MWO 9-2330-392-20-2

MODIFICATION WORK ORDER

MODIFICATION OF
TRAILER, CARGO: 2-WHEEL M1101
(2330-01-387-5443) EIC: CBC
TRAILER, CARGO: 2-WHEEL M1102
(2330-01-387-5426) EIC: CBB
CHASSIS, TRAILER: 2-WHEEL
(2330-01-387-5424) EIC: CCL

This modification is to provide a procedure for replacing the rivets used to secure the landing leg mounting bracket. Bolts and nuts will replace the rivets.

Figure 5

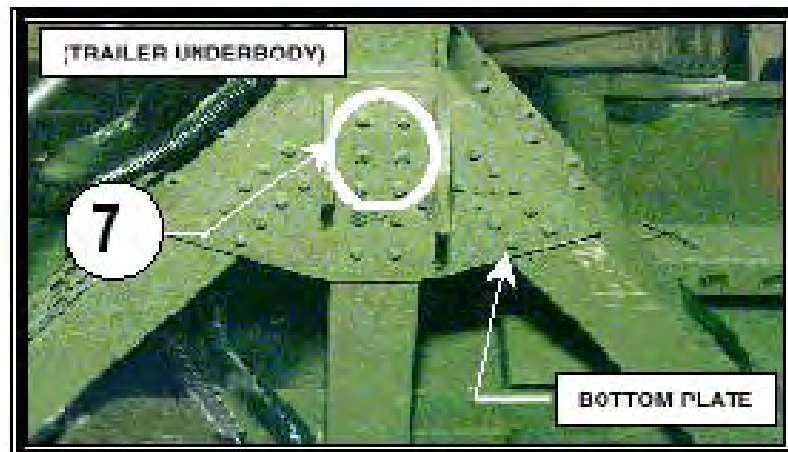
5. Locate and mark the six rivets (7) to be removed. Remove the six rivets (7) from landing leg mounting bracket attached to the bottom plate using one of the two methods described on following page. Store landing leg mounting bracket for later installation on this trailer (**see Figure 5**).

Figure 16

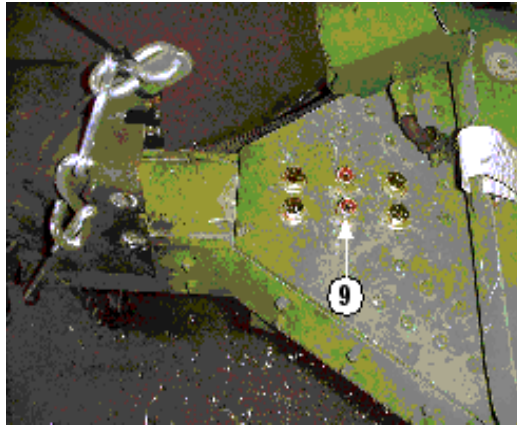
10. Secure the landing leg mounting bracket with four 3/8" locknuts & flat washers. Do not fully tighten the bolts/nuts. Insert two 3/8" bolts with flat washers from the bottom through the two middle holes and secure with 3/8" locknuts & flat washers (9). Torque all bolts to 35 ft·lbs. Recheck torque on all bolts (**see Figure 16**).
